Addendum #1

Attn: Estimator	Date: November 14, 2024
From: Lisa Donahue, Project Administrator	Pages: 58 (including cover page)
Re: Bullock Creek School District 2024 Bond Series 1	Project: 2025 Summer Projects HS/MS/Elem/Pine River/Floyd and Maintenance Building
CC:	Proj. #: A24907

Project: No. 24-120 2023 Bond – Series 1 2025 Improvements

Issue Date: November 14, 2024

PROJECT 'F'

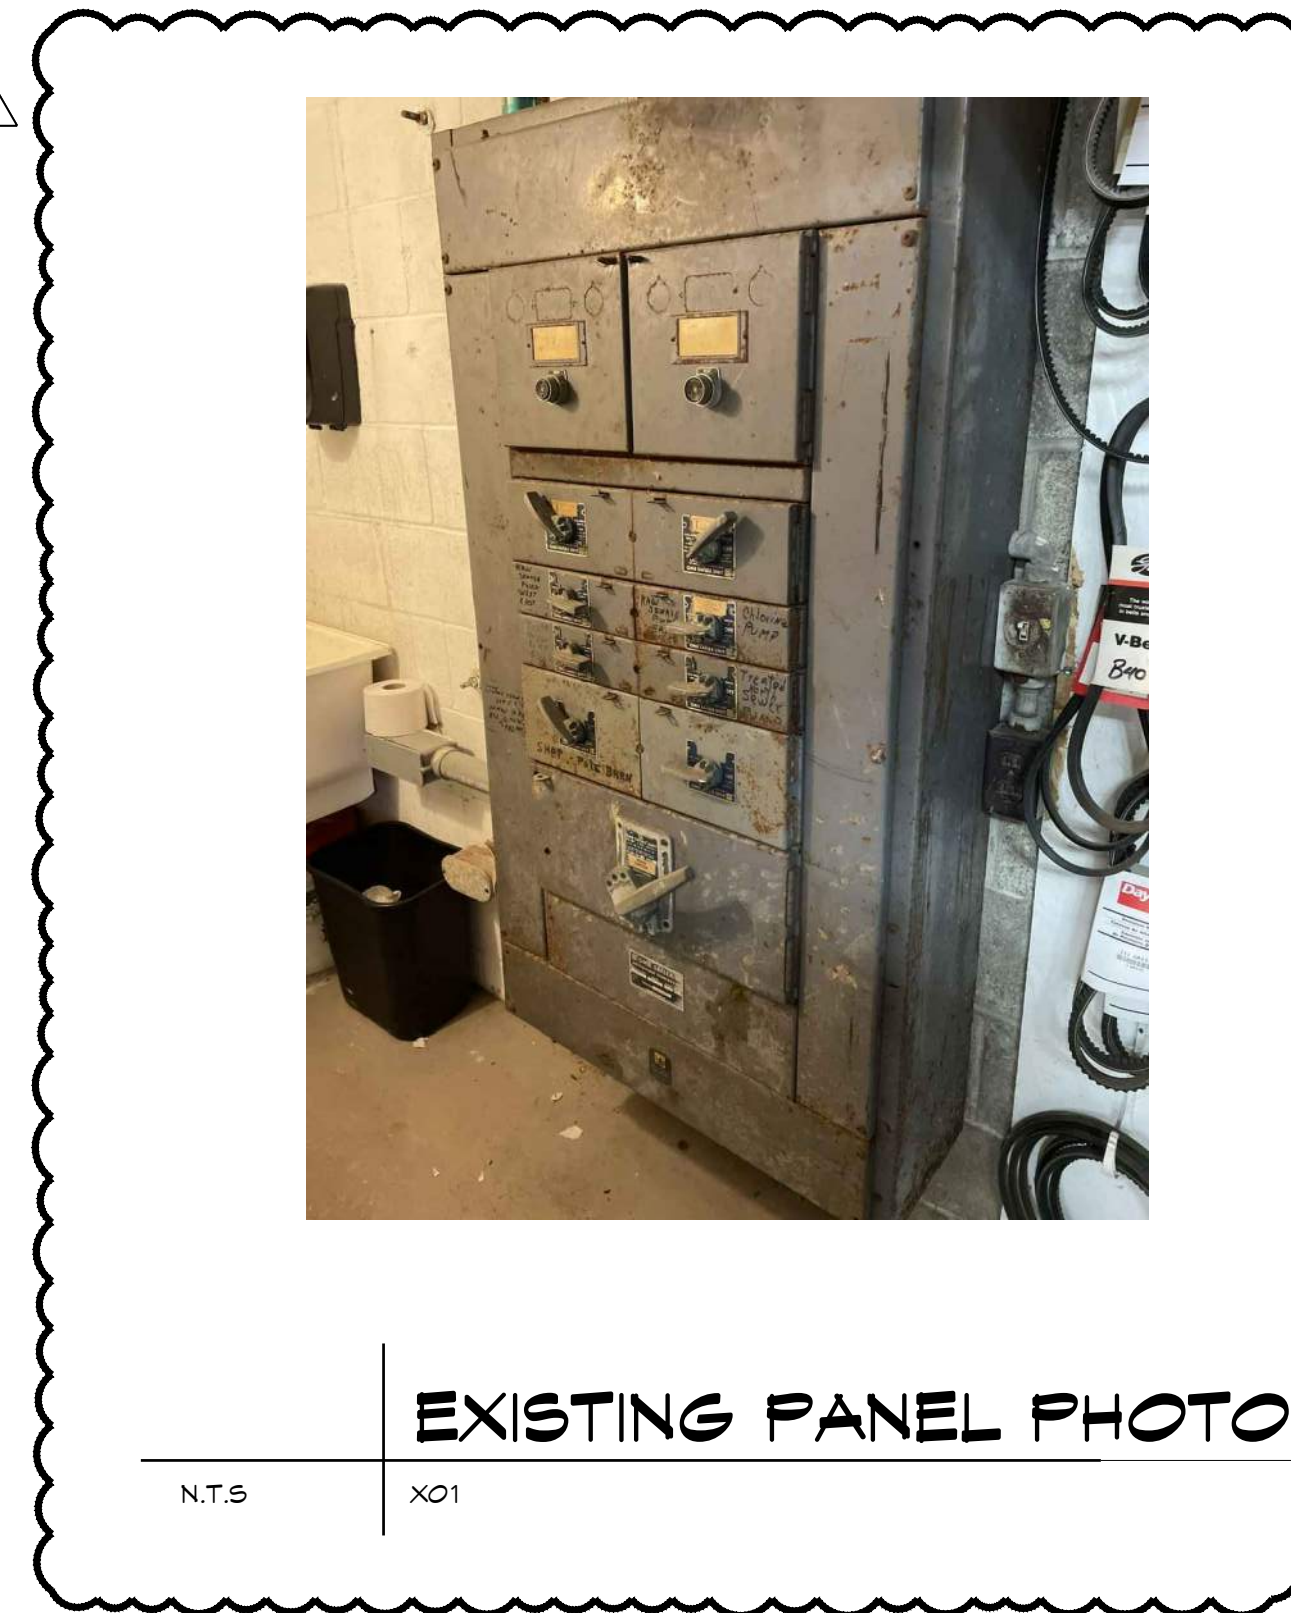
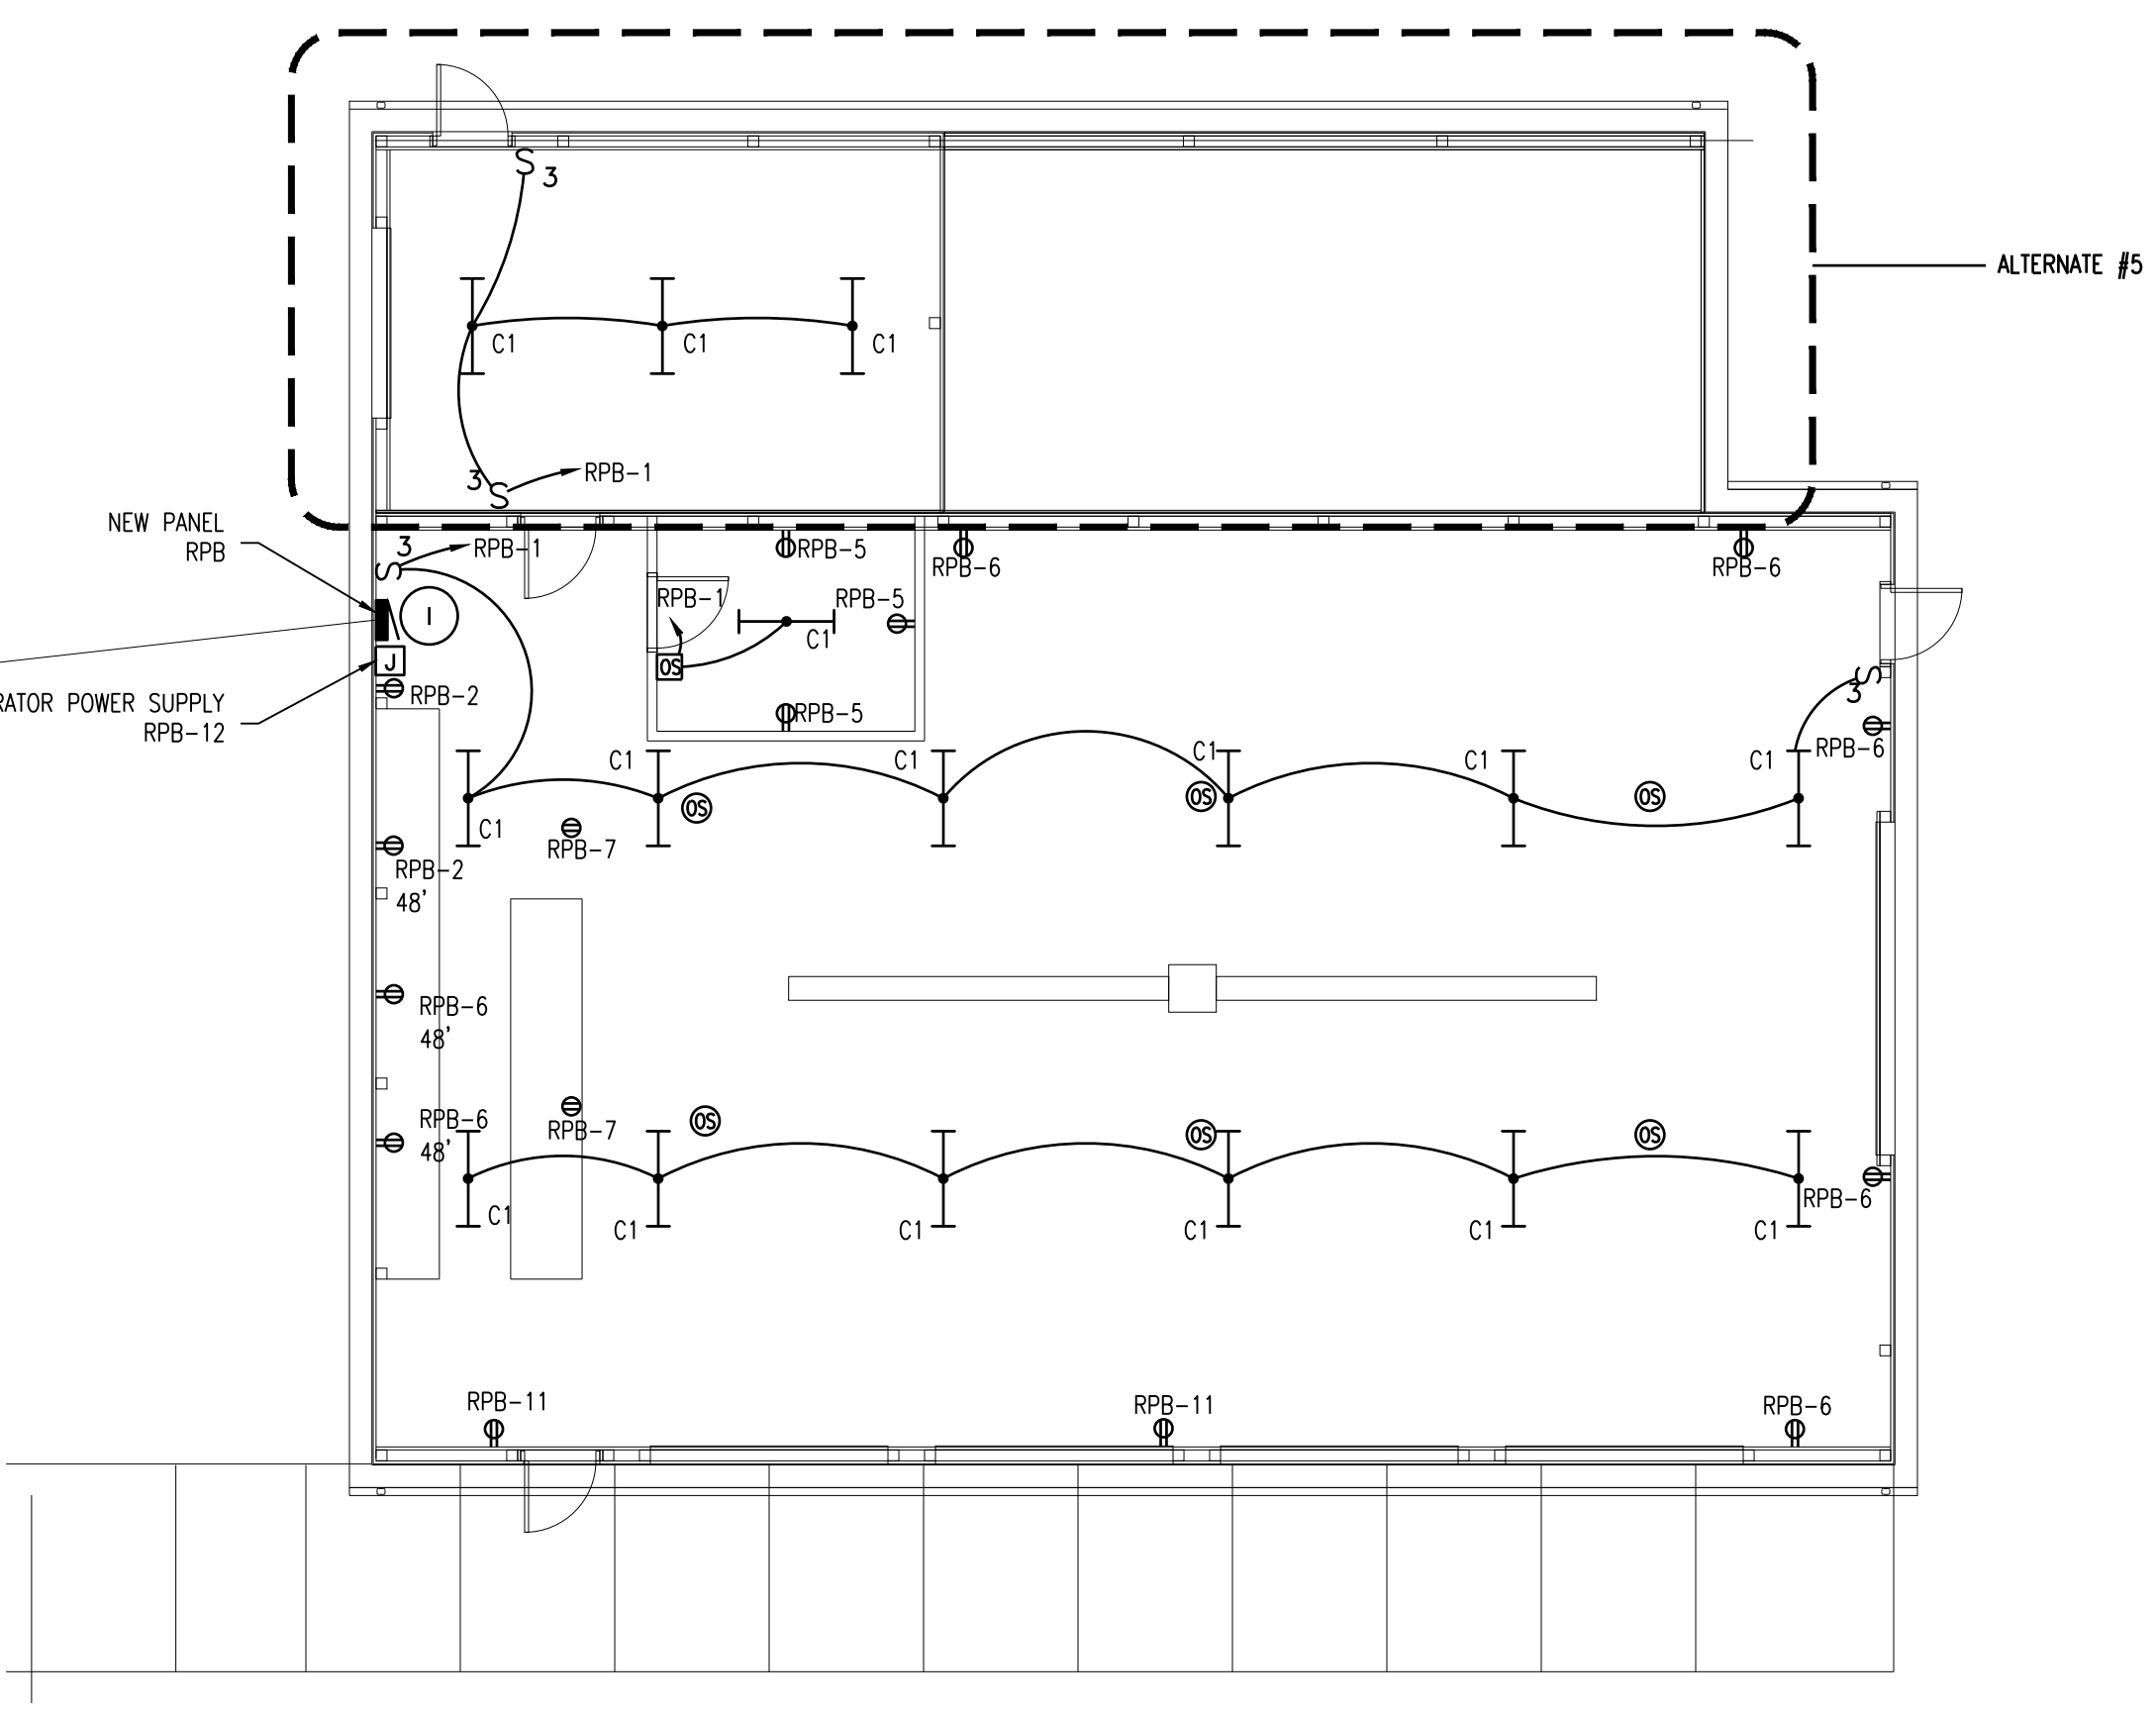
Item #E2: Revise Sheet F-E102 as follows:
a. Picture added of existing panel in existing shed for clarity of work.
